Technical Memorandum

To:	John Woods
From:	John Knutson, PE URS Corporation 3810 Kern Rd., Suite A Yakima, WA 98902 (509) 469-0163
Copies:	File
Date:	July 29, 2014
Subject:	Review and Comments on Flood Study for Black Horse
Project:	33764776—Bender Road Flood Review

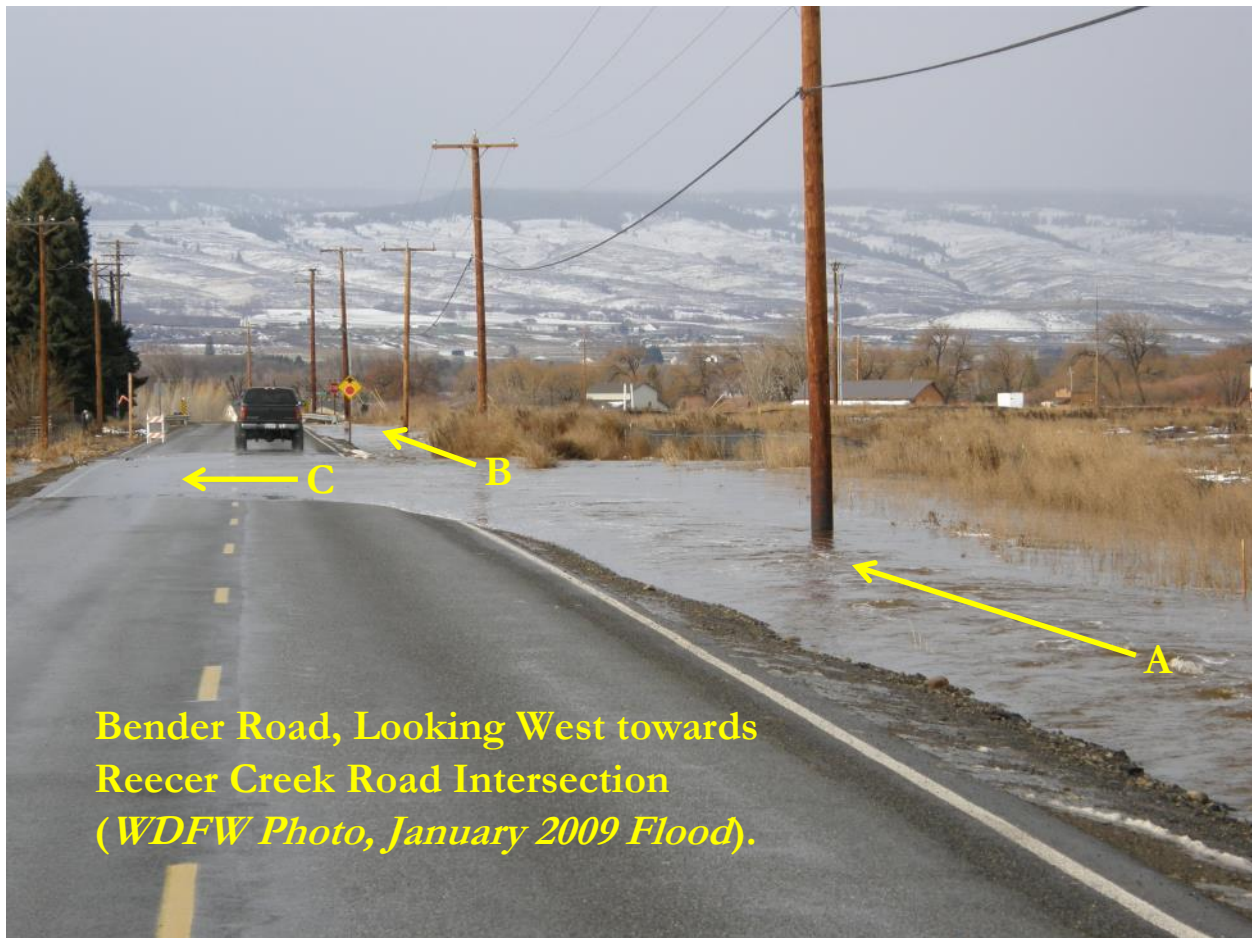
- A. Anchor's model accurately shows that under existing conditions a substantial amount of flood water cannot pass through the existing Bender Road culvert, and instead is diverted to the west along the upstream side of Bender Road where a portion of it overtops Bender Road and a portion overtops the Town Canal banks near intersection of Bender Road and Reecer Creek Road (**Figures 1 and 2**).

Figure 1. Whiskey Creek floodwaters flowing west away from the creek along Bender Road. **A.** Based on Anchor's model using the estimated 1996 flood flow, the diverted flow would be approximately 283 cfs for a Whiskey Creek flood flow of 378 cfs (*likely greater than the 2009 flood flow shown here*). **B.** The majority of diverted flow overtops the Town Canal banks and leaves the area. **C.** A smaller portion of the diverted flow overtops Bender Road (shallow enough to still see road stripes in 2009) and enters the roadside ditch where it flows into the Town Canal on the south side of the road. In 1996 the flow overtopping Bender Road was great enough to overwhelm the capacity of the south side ditch and enter Woods field.

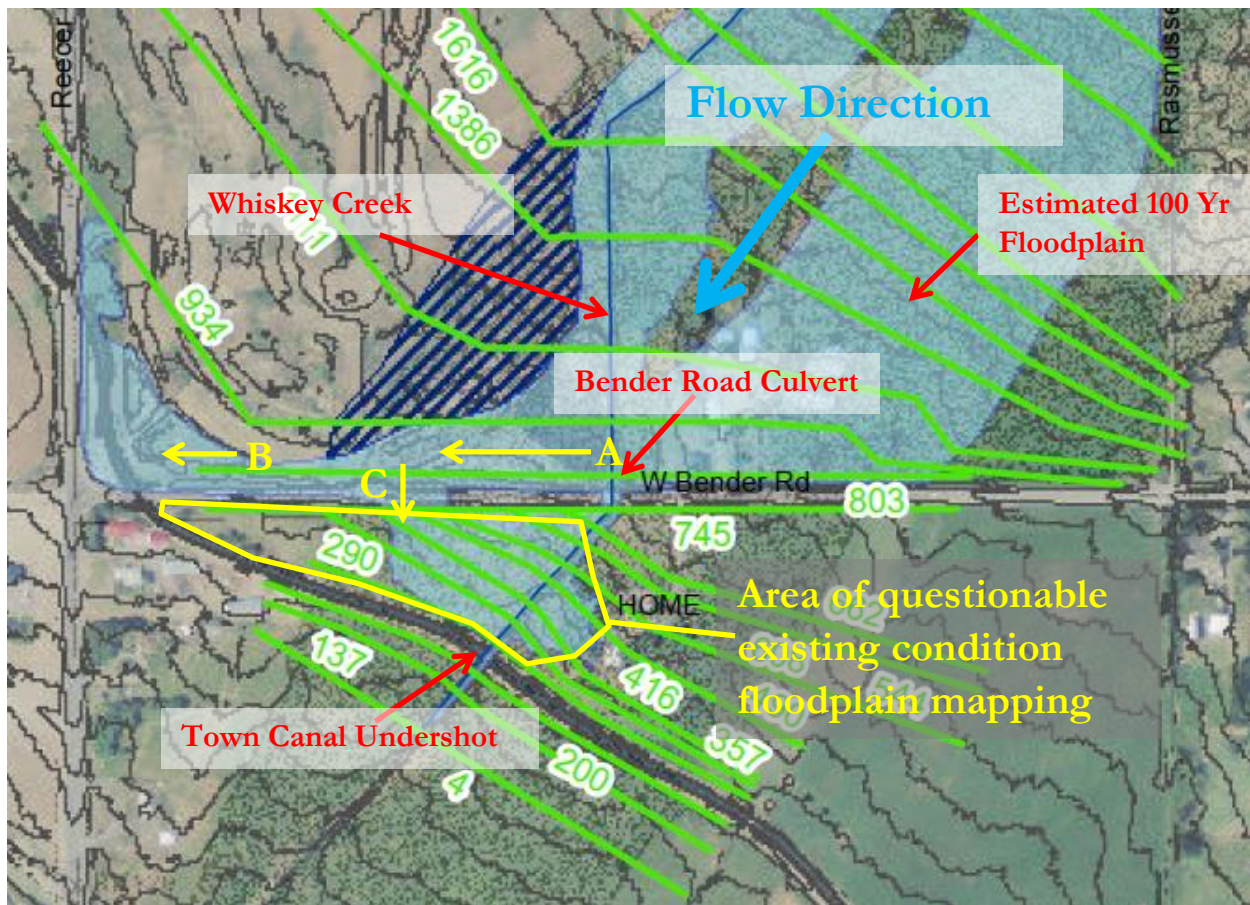
Figure 2 (Edited from Anchor Floodplain Analysis, Sept. 28, 2012). Anchor model shows Whiskey Creek floodwaters flowing west away from the creek along Bender Road. **A.** Based on Anchor’s model, the diverted flow would be approximately 283 cfs for a Whiskey Creek flood flow of 378 cfs. **B.** The model shows the Town Canal being over-topped. **C.** A portion of the diverted flow is shown crossing Bender Road and entering John Woods field.

- B. While the diversion of flow along Bender Road and the overtopping of the road and the Town Canal appear correct, the floodplain mapping on the south side of Bender Road does not appear to be correct (**Figure 2**). Nor does it match Mr. Woods’ observations over the last 30 years, during which several floods have occurred with the largest occurring in 1996. The floodplain mapping does not match the Anchor HEC-RAS model output either. There are several inconsistencies:

Figure 3 (Edited from Anchor Floodplain Analysis, Sept. 28, 2012). Shows 2 ft contours, low topographic rise, the direction that floodwaters that overtop Bender Road should flow, the low area along the canal, and the zone where overtopping and flow into the canal occurs.

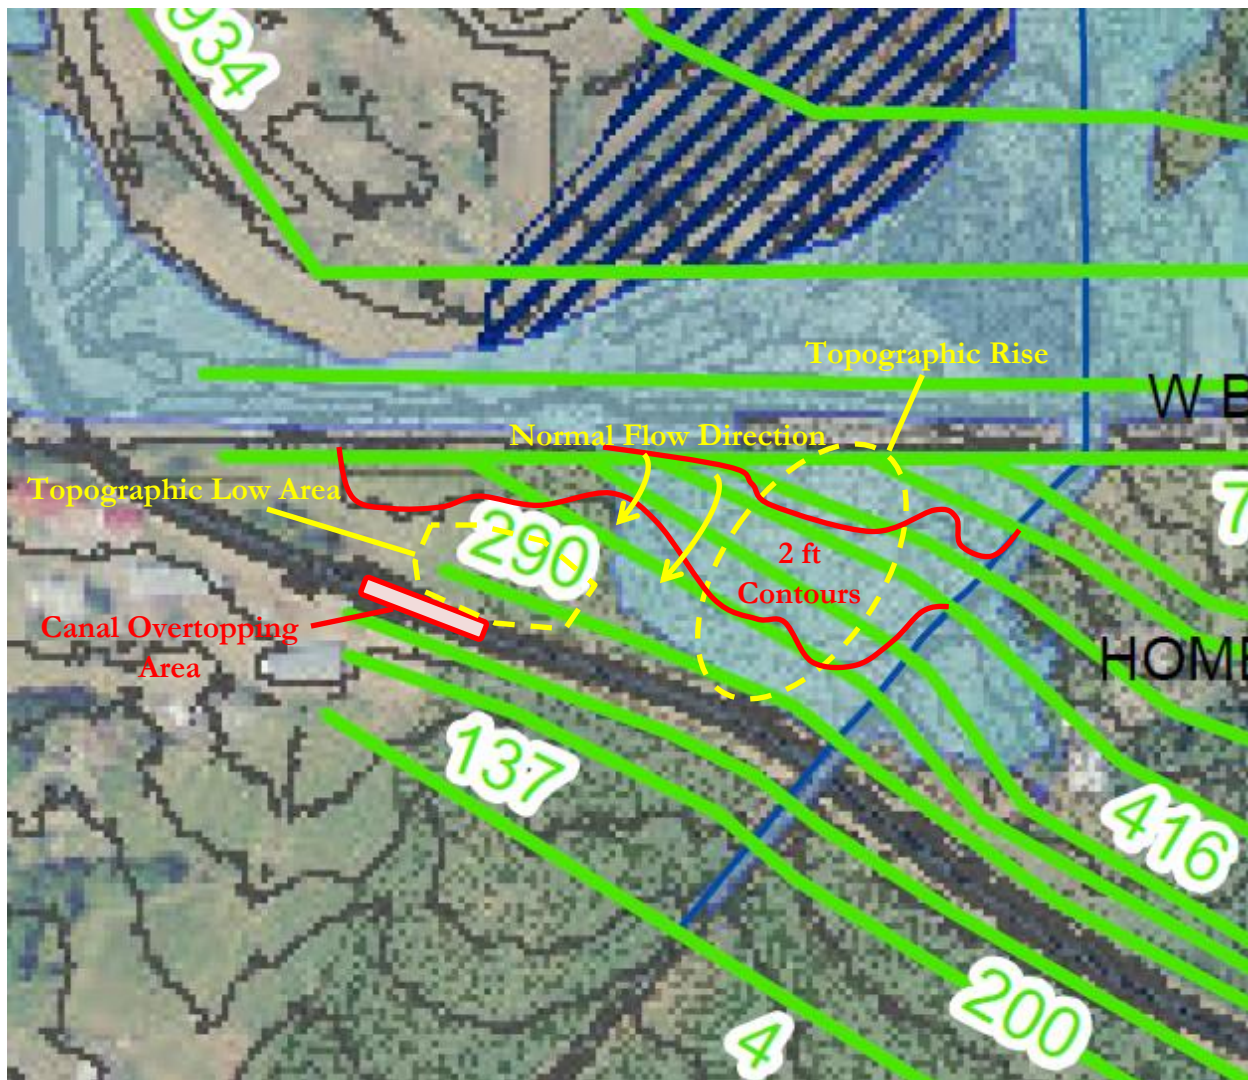
- i. Once the diverted floodwater overtops Bender Road, based on the 2 ft contours the Anchor mapping essentially has it flowing up-hill, across a low topographic rise, and back down to Whiskey Creek. While it may be slight, the topographic rise can be observed in the field and is also shown in the 2 ft contours. The 2 ft contours (presumably derived from LiDAR data) show that, once overtopping Bender Road, the floodwater should: (a) flow down the south side ditch and into the canal on the south side of Bender Road; and (b) when over topping flows are great enough (such as in 1996), flow downhill (perpendicular to the contour lines) in the field and pool in the low spot in the vicinity of the “290” location (**Figure 3**). There appears to be no reason to map as floodplain the entire area between the road overtopping location and the creek/canal undershot.

Once pooled near the “290” location, there is no topographic reason the floodwater will not overtop the Town Canal bank and enter the canal rather than return to Whiskey Creek (which is what Mr. Woods has observed). In fact, prior to 1996 Mr. Woods and the Ellensburg Water Company installed a “cut-out” on the side of the canal at the low spot in the field to drain excess irrigation water from the Woods field – this is how floodwaters from the field entered the canal in 1996. This flooding pattern is also validated by a video of the 1996 flood provided by Mr. Woods. The video (1:12:46) shows the road being overtopped (deeper than 2009), yet the field between the overtopping location and the creek channel is still covered with snow (1:12:34) - not inundated with floodwater as shown by the Anchor floodplain map (see **Figure 4**). The video shows Bender Road being overtopped in the same location as in 2009, and shows floodwater entering the Town Canal near the intersection of Bender Road and Reecer Creek Road (1:13:27).

Figure 5. Tilting of the HEC-RAS model x-sections in what appears to be a downhill direction, which can lead to overestimation of floodplain limits.

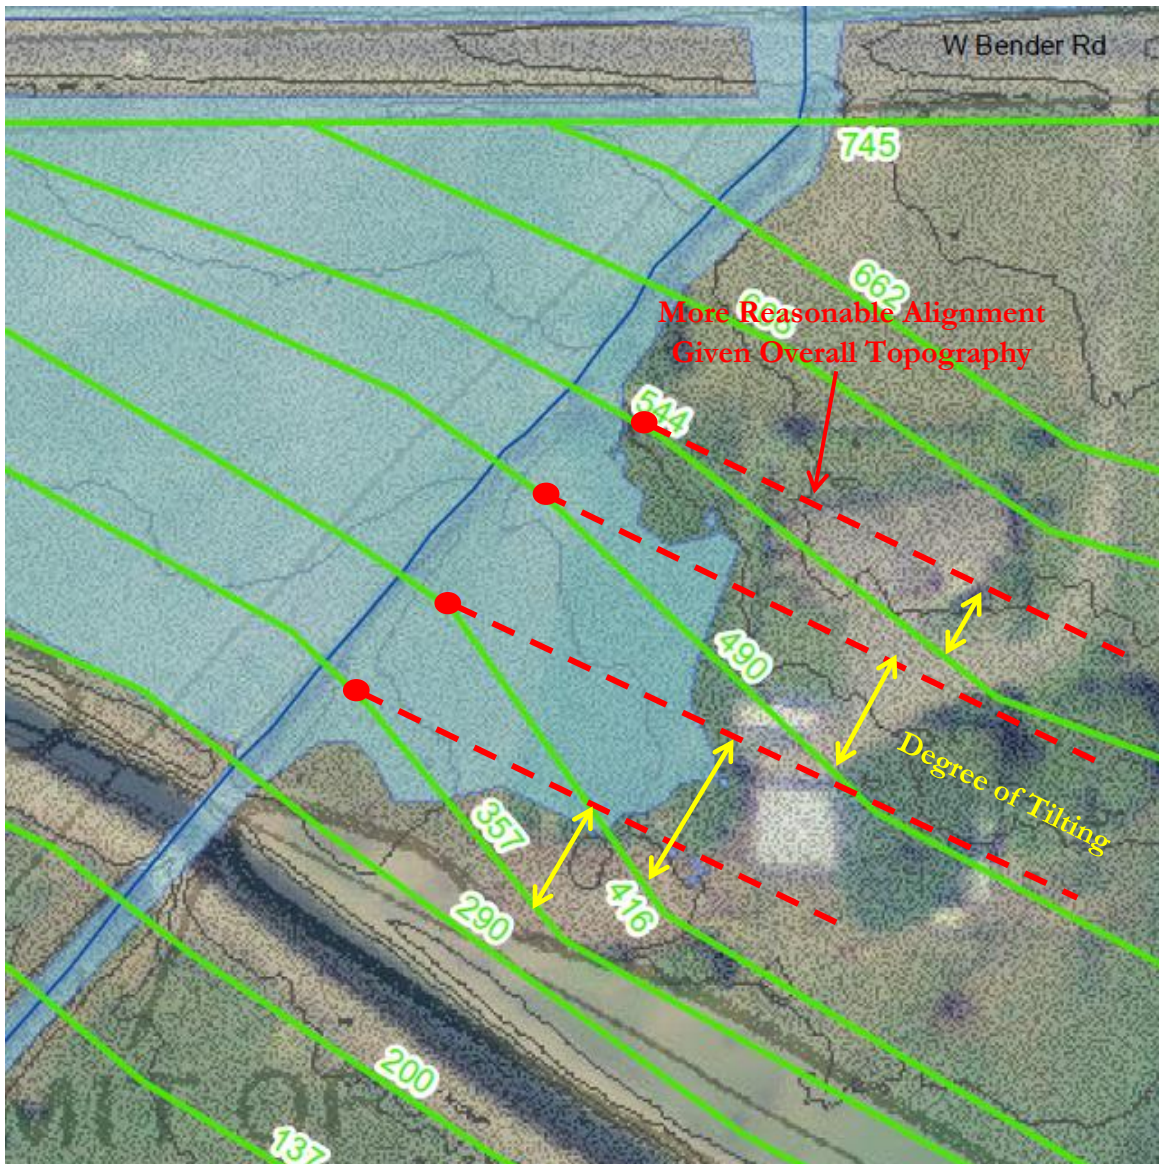
One possible reason some width-of-flow estimates are wider than observed may be the x-section data. It appears that portions of x-sections 490-357 are aligned in a downhill direction on the east side of the creek, which would increase the estimated extent of inundation (**Figure 5**). For instance, if not aligned downhill, x-section 490 (flow width of 95 ft) would intersect with a 2 ft contour line about 150 ft from the creek. With its somewhat downhill orientation, it does not intersect the 2 ft contour even after 400 ft. X-section 416 appears to be aligned in an even more downhill direction but its width-of-flow is estimated at 12 ft.

In any case, the floodplain area shown on the existing condition map (Figure 3 of Anchor's Sept. 28, 2012 Memo) does not match Table 1 of the same memo. For instance the predicted width of flow at x-section 490 is about 95 ft, which would inundate about 47.5 ft on each side of the creek, assuming the creek is in middle of the inundation area. Anchor's map shows x-section 490 being inundated by about 150 ft on the east side of the creek alone. The discrepancy is greater for x-section 416 with an 11.8 ft predicted width of flow in Table 1, but a mapped width of flow of about 180 ft on the east side of Whiskey Creek alone.

Figure 6. URS mock-up of more correct floodplain on John Woods property (yellow shading) based on Anchor’s Table 1 (X-Section/Width-of Flow): 745/899.62 ft, 662/38.62 ft, 608/89.66 ft, 544/22.21 ft, 490/94.71 ft, 416/11.83 ft, 357/19.66 ft, 290/12.77 ft.

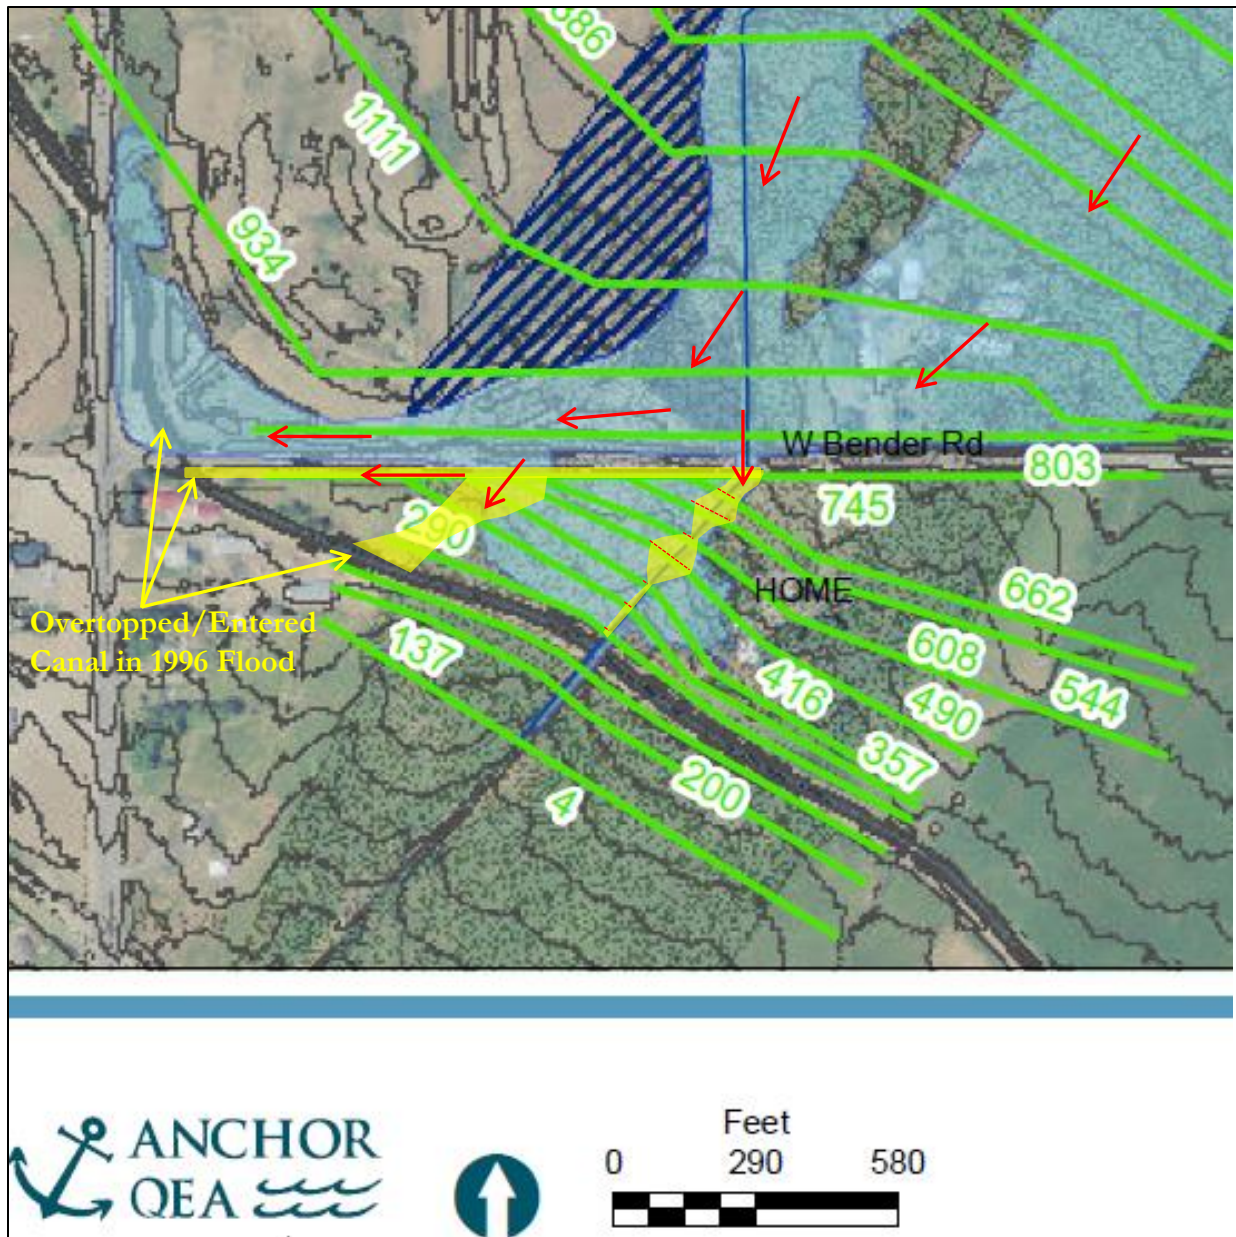
While there are still some inconsistencies between the model output and the Woods observations, Anchor's HEC-RAS model output (Table 1 from Anchor Sept. 28, 2013 Memo) can be used to develop a better estimate of the existing condition floodplain along Whiskey Creek through the Woods property. URS has prepared a mock-up of the existing condition floodplain map using Anchor's width-of-flow information for the reach of Whiskey Creek crossing the Woods property (**Figure 6**).

Figure 7. Anchor’s estimated floodplain limits on the Woods property under the proposed conditions (Anchor Sept. 28, 2012 Memo). *The accuracy of the proposed condition mapping should be carefully reviewed for some of the same reasons discussed above.*

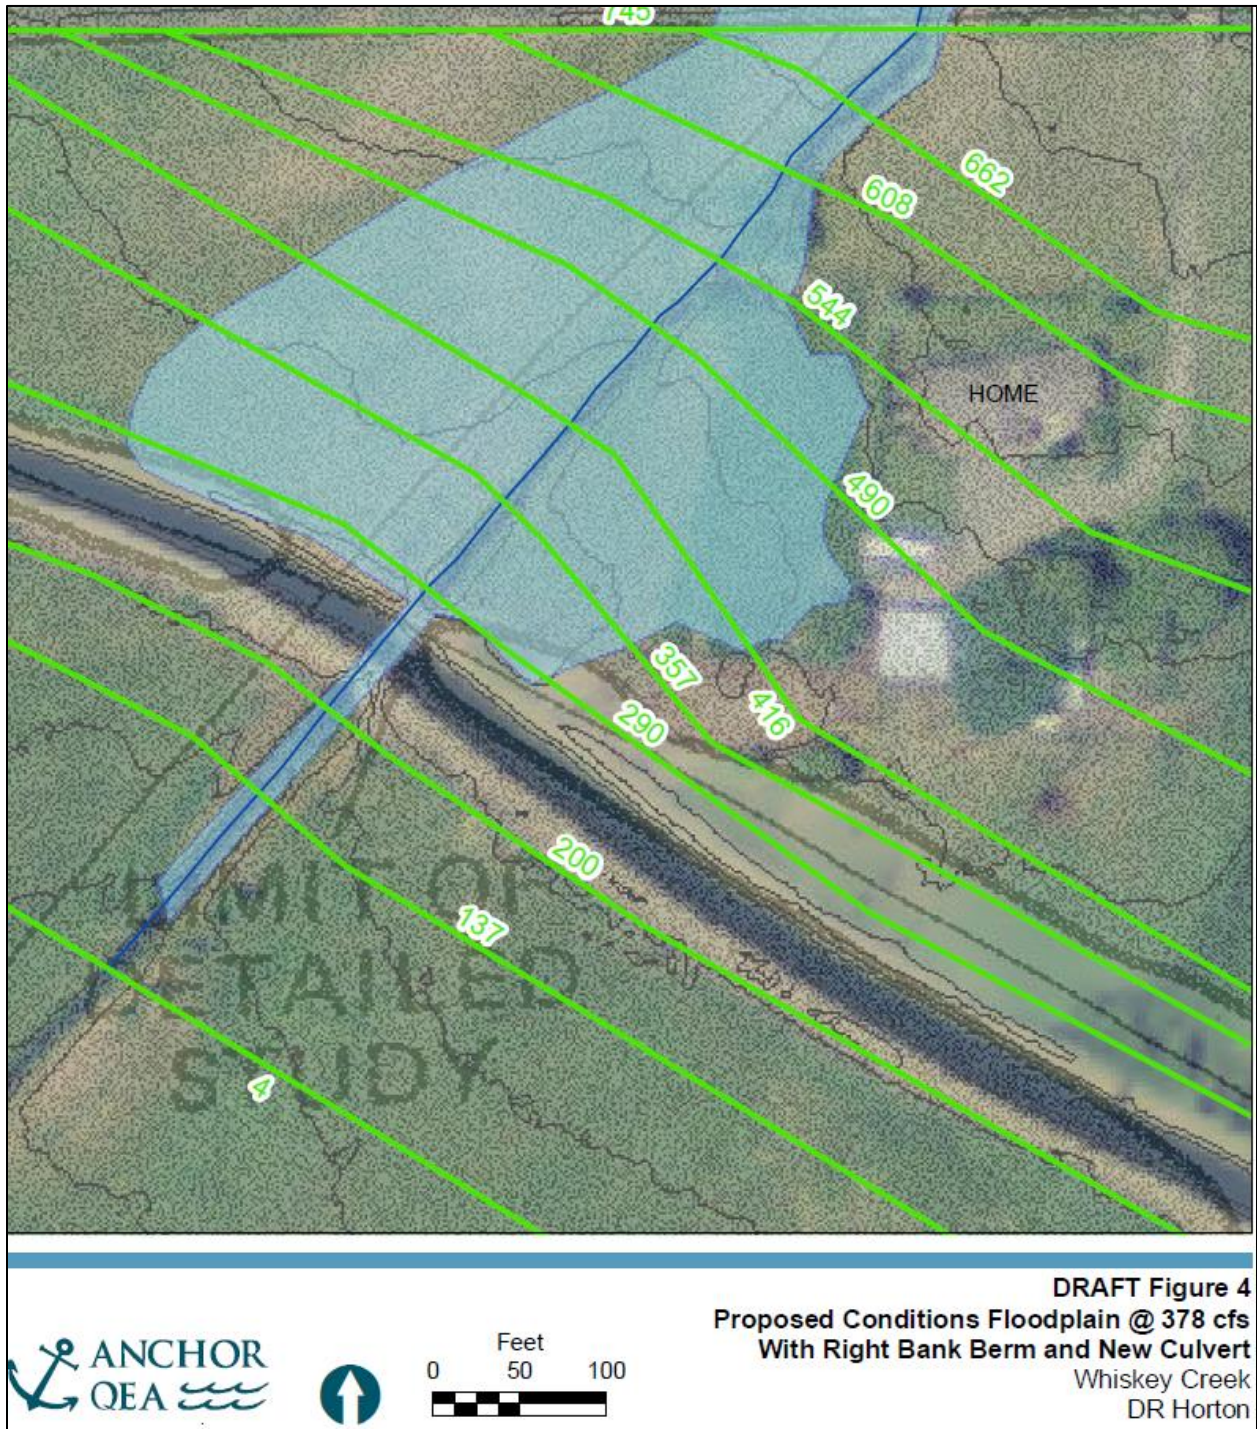
Therefore the reach is estimated to have a 400% increase in flow compared to existing conditions (378 cfs vs. 94.5 cfs). The proposed floodplain on the Woods property is shown in **Figure 7**. In addition to the increase in peak flow rate, there is a corresponding increase in channel velocity, depth, and width-of-flow.
